# Rezoning Transportation Analysis

Petition Number: 2023-080

## Revision Log:

| Date     | Description        |
|----------|--------------------|
| 10-26-23 | Third Review (JP)  |

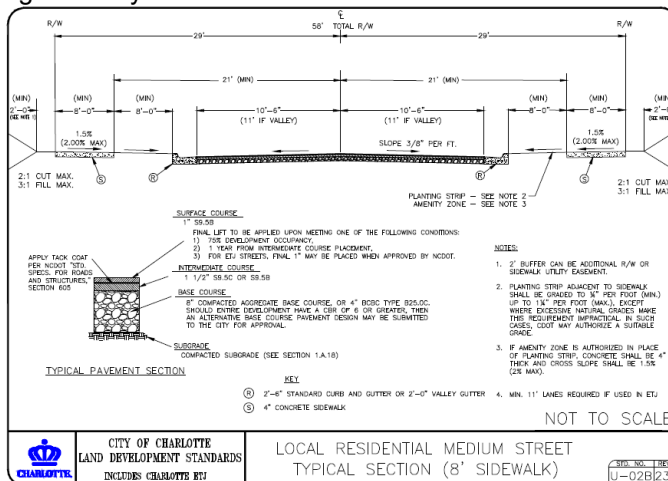
- a. **Forest Point Boulevard:** Future curb line is in the existing location

Clarifying Comment 10.26.23: From the centerline of Forest Point, label and dimension the ROW and back of curb.

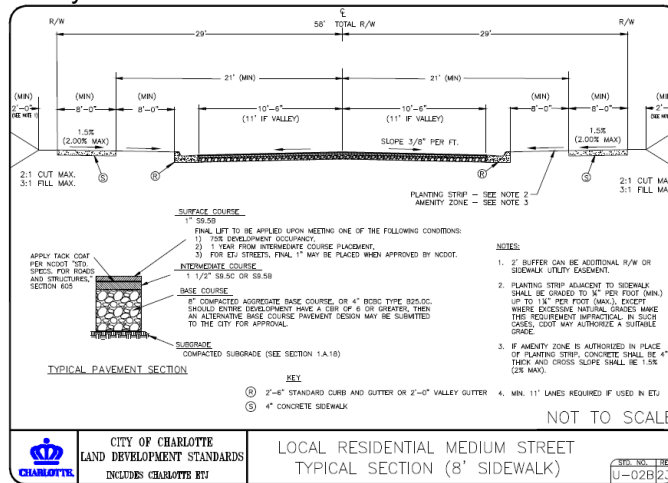
e. ~~Proposed Public Street: Cross section is local residential medium (U-02B) with 58' of right-of-way.~~

**Clarifying Comment 9.20.23:** U-02B should be used based on the zoning district N2 and street type.

Label and dimension the curb and gutter from the centerline for each road on the site plan.

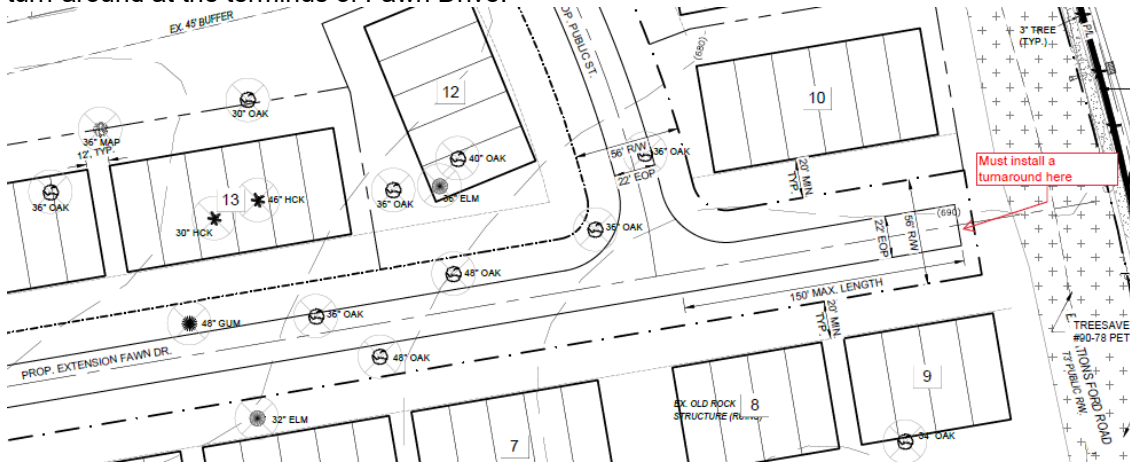
3. ~~Revise site plan and conditional note(s) to commit to construct an 8-foot planting strip, and 6-foot sidewalk on Forest Point Boulevard per UDO 32.7(D)(b)(ii); 8-foot planting strip, and 8-foot sidewalk on both sides of Fawn Drive Extension per UDO 33.3(D); and ); 8-foot planting strip, and 8-foot sidewalk on both sides of Proposed Public Street per UDO 33.3(D). The site plan shall label and dimension both items from the back of curb and gutter or edge of pavement.~~

**Clarifying Comment 9.20.23:** 1) It is ordinance requirement, including 6' sidewalks in N1, 2) responsibility for adjustments from the ordinance requirement for sidewalk fall under the planning department and would occur during permitting 2) sidewalk cost reimbursement is available for affordable housing developments that meet the City's affordable housing criteria.
